**SUPPLEMENT**

# **Hudson**

## **MECHANICAL PROCEDURE MANUAL**

This manual is a supplement to and is to be used in conjunction with the 480-490 Mechanical Procedure Manual.

FIGURE 1

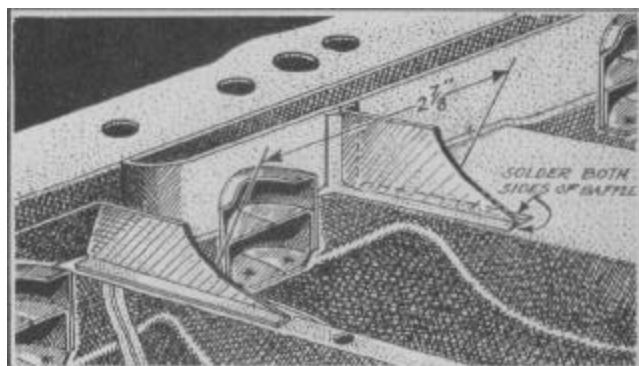
A sheet metal baffle has been added to the oil pan tray as shown in Figure 1.

The addition of this baffle gives better control of the movement of the oil in the oil pan tray, raising the level of the oil in the tray for better lubrication.

This baffle Part No. 302539 became effective in production on all 8 cylinder engines after March 1, 1949 and can be installed on previous models by soldering as illustrated in Figure 1.

FIGURE 2

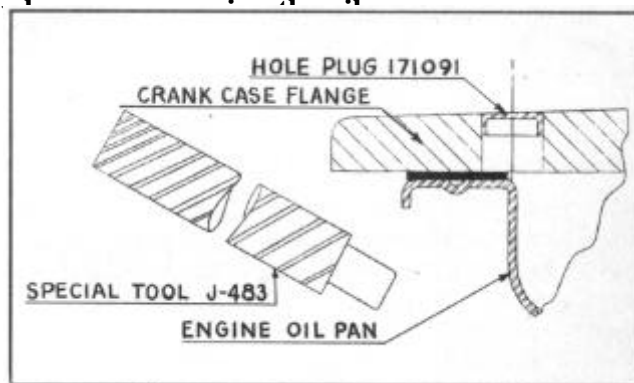
**CAUTION:** The cylinder block machining locating hole at the left rear side of the cylinder block base is so located that one half of the hole opens into the crankcase. A cup shaped plug 9/16" outside diameter is used to close this hole after machining, Figure 2.

A new plug can be installed (with J-483 vibration dampener installer tool handle) from below the engine with the oil pan removed, or from above by removing the starter motor; always apply white lead or sealer to the cup before installation; plug should be positioned as shown in Figure 2.

FIGURE 8

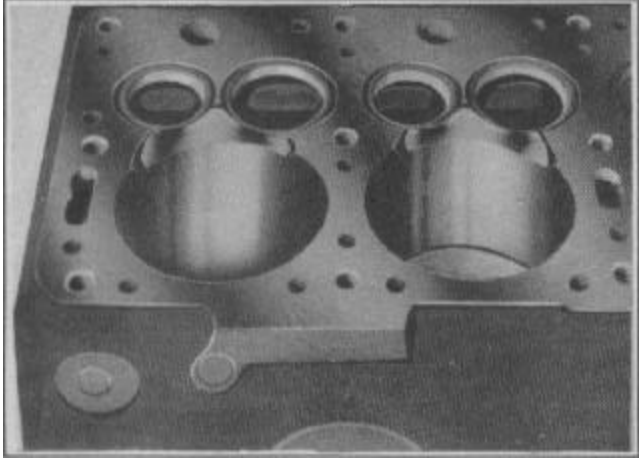
Due to an engineering change effective with car number 491-95958, production made a change in finishing the cylinder top face by machining an 1/8" deep tapered depression beginning at the valve seat

chamber and extending to the cylinder bores. Figure 8.

This machining change necessitated changing the position of the piston ring locating pin for the upper piston rings from 44° from a center line through the piston pin to 20° from the same center line to facilitate installation of the piston assembly.

FIGURE 9

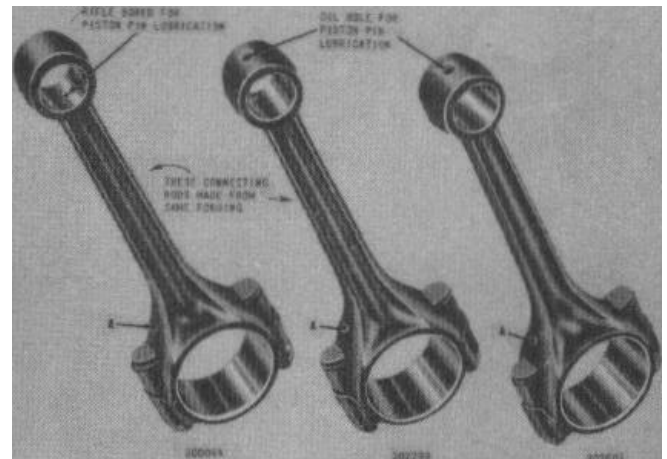
Additional information on 6 cylinder connecting rods as follows: Starting with car serial No. 482-108180 the process of rifle boring the connecting rods part 300044 for the 6 cylinder engine has been discontinued and superseded by a non-drilled rod, part no. 302293 which provides for piston pin lubrication through a drilled hole at the top of the connecting rod. Figure 9.

Beginning with car Serial No. 491-52515 a third type connecting rod (forging No. 302601) is used. In this type rod the "I" beam section has been changed. The center raised section has been removed and a full "I" section adopted.

FIGURE 12

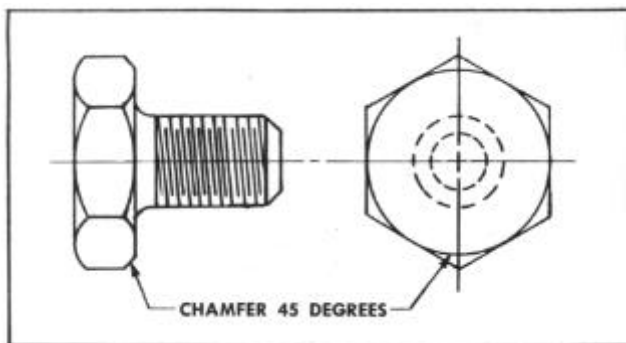
If an inspection proves the cap screw lock is contacting the outer member of the dampener, remove the center cap screw, bevel the outer corners underneath the hexagon head as shown in Figure 12. After re-machining, reinstall the cap screw and tighten to 110 lbs. torque; bend all lips of the locking washer over the flat of the cap screw.

**NOTE: The later type vibration dampeners have the dampener hub lengthened to provide adequate clearance between the cap screw head and the outer member.**

FIGURE 13

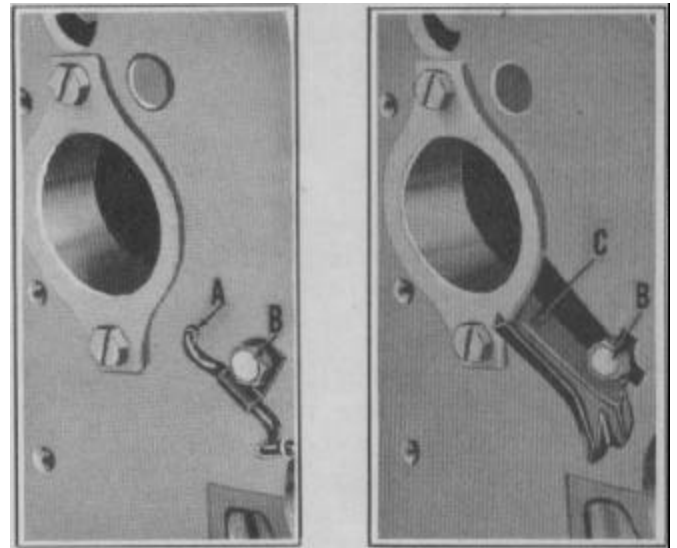
Starting with car Serial No. 491-55683, an oil trough Part No. 302513 is used replacing the oil tube to convey oil to the timing chain. This change was made to eliminate the possibility of stoppage of the oil supply to the chain, due to clogging of the restricted end of the oil tube.

same screw previously used to hold the oil pipe in place, Figure 13. With the new trough installation, the hole drilled for the old type tube oiler is discontinued.

1. Remove the screw and clip (B) attaching the oiler tube to the cylinder block.
2. Using a  $21/64$ " drill enlarge the present  $3/16$ " oil hole (A).
3. Tap the  $21/64$ " hole to accommodate a  $1/8$ " headless pipe plug.
4. Install part No. 817 headless pipe plug.

5. Install trough (C) as illustrated in Figure 13, and secure with screw (B).

FIGURE 18

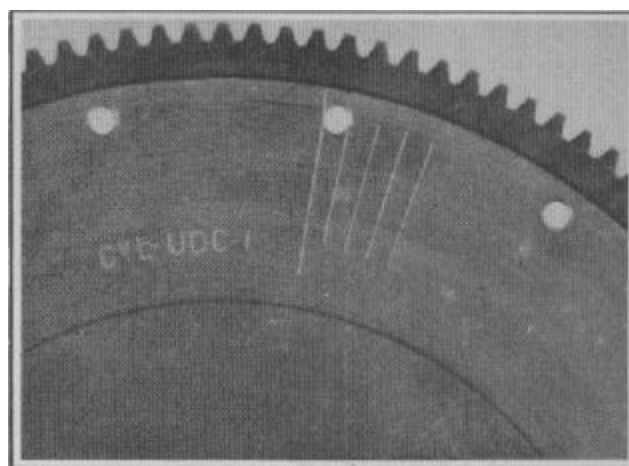
Flywheel assembly, Part No. 166302, which was previously specified for the 480-490 series six-cylinder engines, has been revised so that the timing marking which read UDC-1-6 now reads UDC-1, Figure 18. This assembly with the changed marking is now being used in production on both six and eight-cylinder engines replacing Part No. 166303 assembly previously used on eight-cylinder engines. This change became effective in production on April 21, 1949.

FIGURE 3

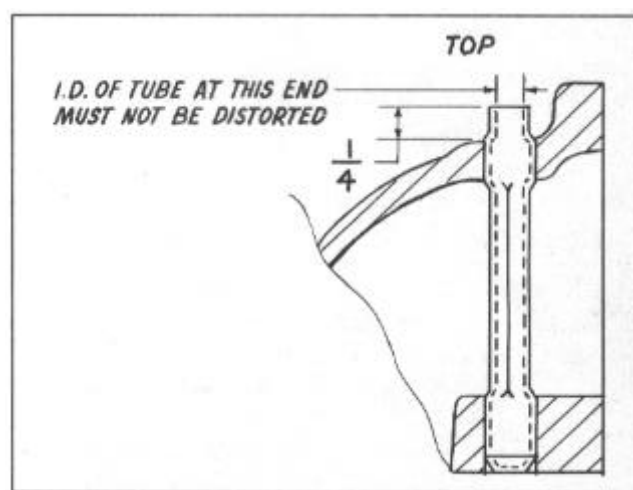
To insure silent passage of air through the exhaust manifold automatic choke heater tube, the lower opening of the tube has been choked at the end to a 3/16" diameter. Figure 3, the new tube part No. 300083 became effective in production August 25, 1949.

The old tube can be removed and the new tube installed without removing the manifold as follows:

1. Remove the air cleaner and heat riser tube at carburetor.
2. Use a piece of 1/4" drill rod approximately 14" long and drive out the old tube from above.

FIGURE 1

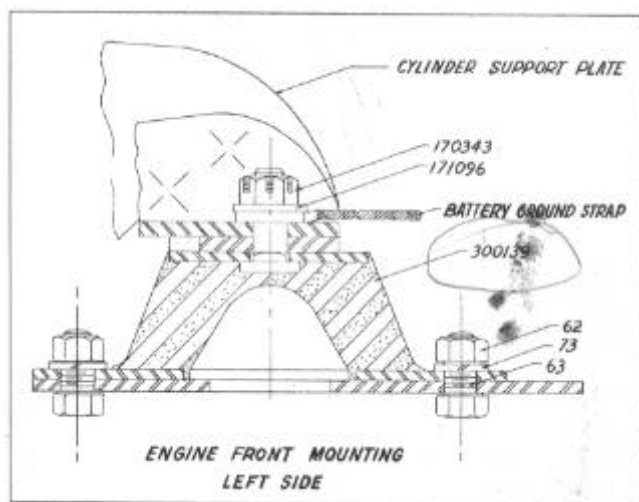
To prevent damage to the ground strap terminal at left engine mount, a plain washer, part number 171096, supersedes the lock washer heretofore used at this point. Figure 1.

FIGURE 2

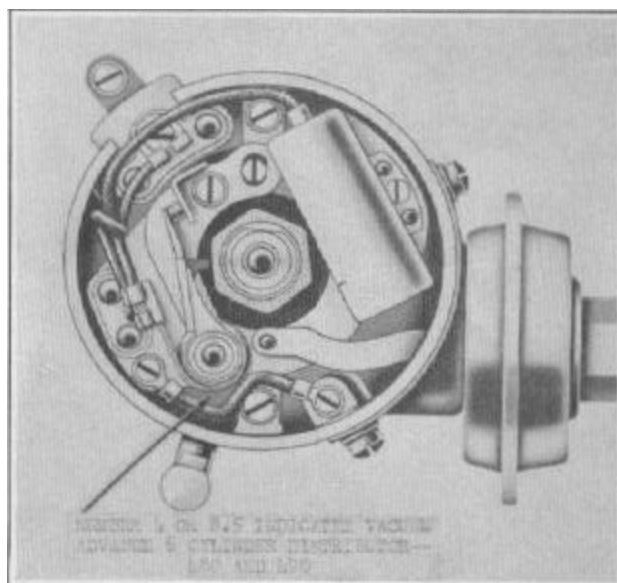
General Technical Policies and Information Bulletin No. 5 dated January 14, 1949 outlined in detail a change in vacuum spark advance from 8.5 degrees to 4 degrees maximum. Although this change became effective with car 491-33913, some of the distributors have been reworked in the field prior to this number. When testing a distributor for vacuum advance always check the number stamped on the breaker plate as shown in Figure 2. This number indicates the vacuum advance. Beginning with car

491-76984 the mechanical advance range was modified. These distributor assemblies may be identified by the vendor part number on the name plate: IGS-4213-1 has a 12 degree advance and IGS-4213A-1 has a 8.5° degree advance.

FIGURE 3

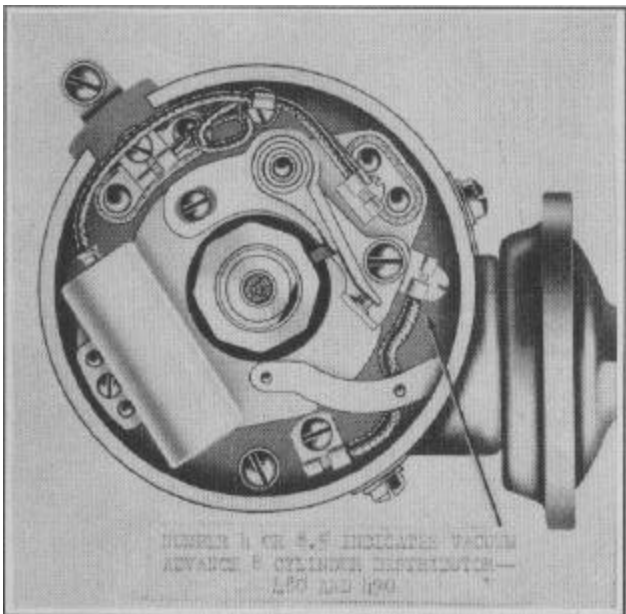
The new distributor with the 4° plate has part number IGT-4204 B-1 on the distributor housing and has a small figure 4 stamped on the breaker plate just opposite the vacuum control diaphragm, Figure 3.

The first type distributor carries part No. IGT-4204A-1 and has a figure 8.5 stamped on the breaker plate. Refer to the specification section of the "Electrical Section" for the latest specifications.

FIGURE 4

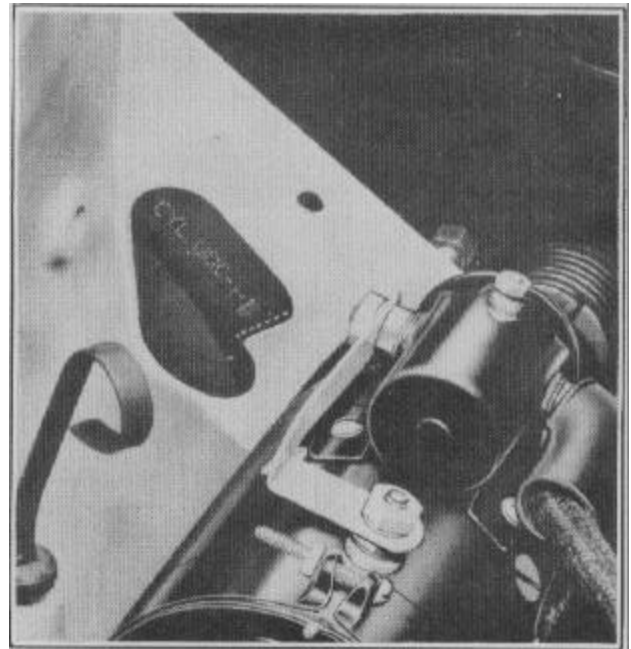
The flywheel markings were revised after April 21, 1949 as follows: "U.D.C. 1-6", and "U.D.C. 1-8" have been changed to "U.D.C. 1" for both 6 and 8 cylinder engines. The figures 6 and 8 immediately following figure "U.D.C. 1" have been removed. Figure 4.

The change in marking will not effect the procedures for the setting of "Ignition timing" and "Fuel and Altitude Compensation" as outlined on pages 6-20 and 6-21 - 480-490 Mechanical Procedure Manual.

FIGURE 1

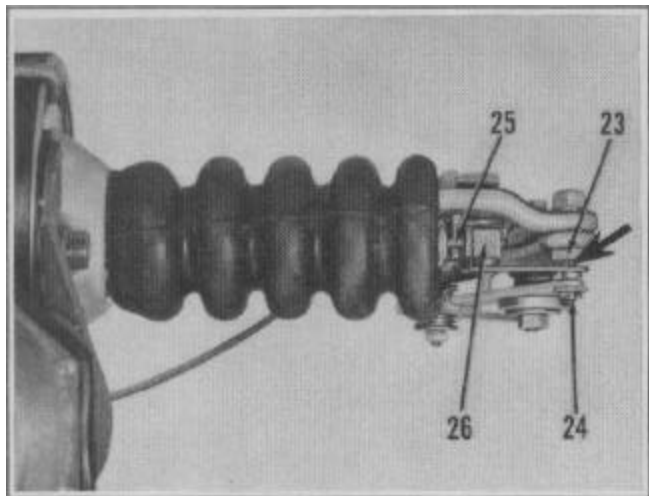
Adjustment No. 8, Page 8-12, should read as follows: Check length of valve rod (applicator valve) (25) Figure 1. If the setting is correct, the center line of the pin (24) will be exactly in line with the center line of the piston rod pivot bolt (23) as indicated by large arrow.

Valve rod (25) can be adjusted by loosening the lock nut and turning the valve rod in or out of the threaded trunnion (26). After making the proper adjustment secure the locknut.

FIGURE 1

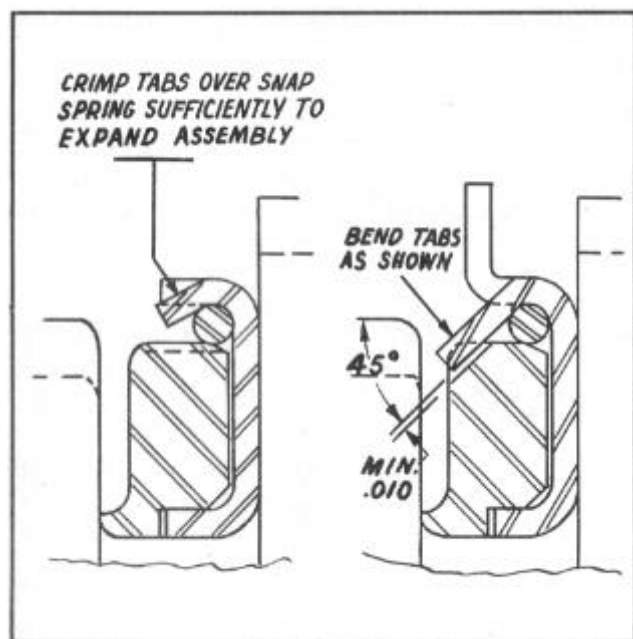
A change was made in the transmission main drive gear, incorporating a stop ring to prevent overshift in high gear position which resulted in premature wear of the shift sleeve and fork.

Transmission Main Drive Gear Stop Ring Spring (1 required) Part 302470.

This stop ring may not be installed on clutch gear shafts not so fitted at the factory due to clearance between the constant mesh gear and direct drive (high gear) teeth. This was affected by a slight change in machined clearance preparatory to the change.

This change began in production on standard transmission (1.65:1 Second speed gear), Dec. 29, 1948 after 22645 cars of 490 series. All other transmissions have had the stop ring on main drive gear since January 18, 1949.

1. Straighten the eight locking ears of the stop ring.
2. Remove lock ring and ring center (die cast).
3. Insert the new stop ring and ring centers and turn ring center in the stop ring 1/4 turn to line up recesses in the ring center with the 8 locking ears on the stop ring.

4. Install wire lock ring and bend all locking ears in recesses as shown in Figure 1.

FIGURE 1

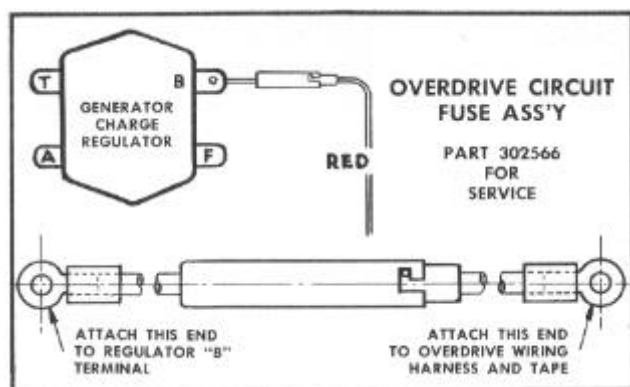
A 30 ampere fuse has been placed in the overdrive circuit in order to protect the harness, solenoid and relay in case of a ground or short. Effective in Production after March 29, 1949.

This fuse is mounted in an insulated holder and located on left front side of dash; the fuse wire end is connected to the "B" terminal of the generator charge regulator as shown above. When replacing the fuse be sure the insulator is in position in the holder.

When it is necessary to replace either the solenoid or relay on account of damage by a short circuit, it is important that the service overdrive circuit fuse and holder assembly Part 302566 be installed.

FIGURE 1

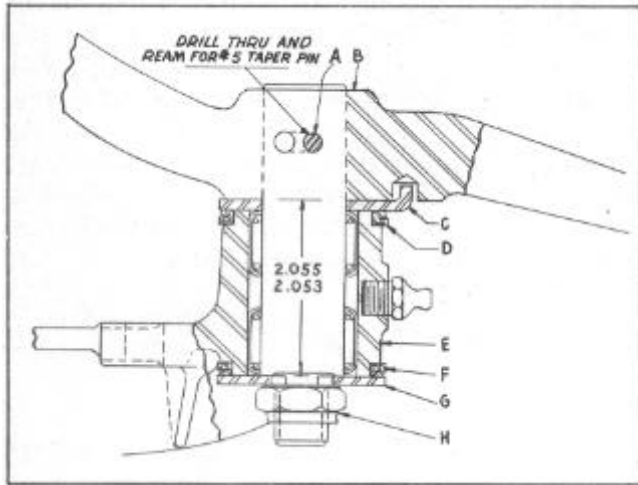
1. When installing new bearings in steering center arm bracket (E) space as shown in Figure 1, apply pressure on outer race, on end carrying manufacturers name and part number.

2. If necessary to replace the steering arm pivot shaft, the new shaft should be pressed in place maintaining the 2.053" to 2.055" dimension as shown in Figure 1 before drilling the hole for the No. 5 taper pin (A).

3. Old type all rubber seal Part No. 300597 has been superseded with Part No. 302553 seals (F) and (D). The later seal is a steel washer bonded to synthetic rubber. A separate retainer is not used with the new seal. The new seal became effective in production after car Serial No. 49173777.

4. When installing the seals the rubber lip faces to the casting as shown in cross-section Figure 1 and the spacers (C) and (G) positioned as shown.
5. The center steering arm pivot bolt nut (H) should be tightened to 50-60 foot lbs.

FIGURE 2

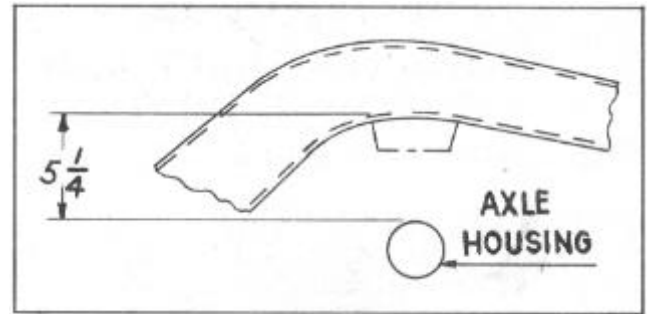
Paragraph 4 should read: Caster and camber are measured when the car is set to 4-1/4" dimension at the front as shown in Figure 6, 480-490 Mechanical Procedure Manual and 5-1/4" at the rear (curb height) as shown in Figure 2, the camber should be 1/2° to 1-1/2° positive.

**Note should read: One complete turn of eccentric bushing changes caster 1/2°. Set caster 1/2° to 1-1/2° positive, but never over 1/2° variation right or left.**

FIGURE 1

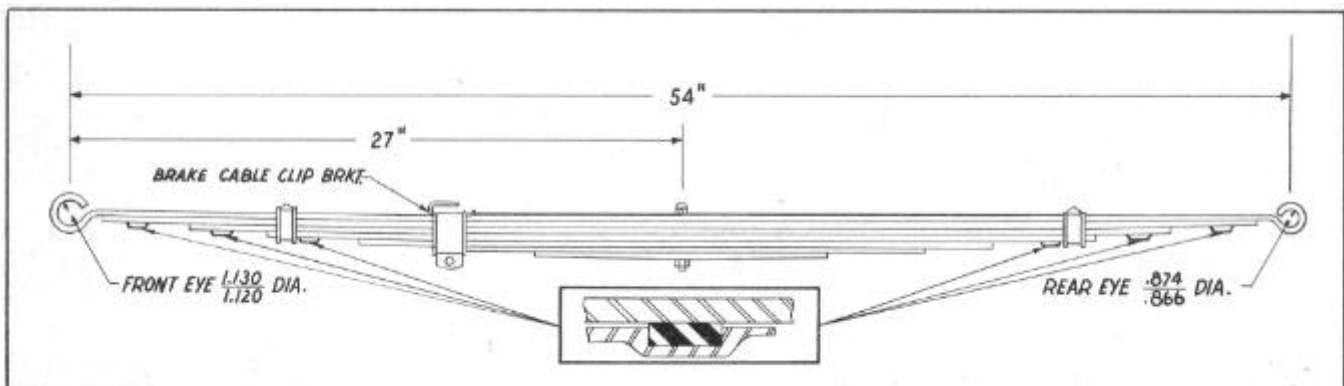
Effective November 14, 1948, production began using as an option for light scale only, a Spring Perch rear spring Part No. 302440 on model 491 Broughams and all Coupes. This spring has rubber inserts at the ends of the long leaves as illustrated in Figure 1. Following.

Under no circumstances should these springs be lubricated as it will affect the rubber inserts; neither should spring covers be applied, as it is intended that they should operate without covers. It is recommended that any replacement be of the same as that removed.

FIGURE 2

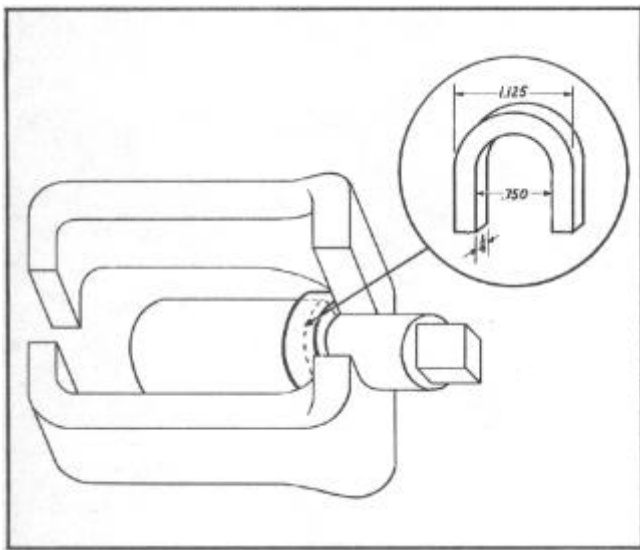
Add the following note: After May 31, 1949 there was released for production a new brake pedal rod which is 1/4" shorter than the pedal rods used on previous production for the 480-490 Series.

To adapt the J-2795 Brake and Clutch Pedal Remover for the shortened pedal rods it will be necessary to add a horseshoe washer 1/4" thick with a slot milled in the washer. The opening in the washer must be large enough to enter over remover adapter; for specifications see Figure 2.
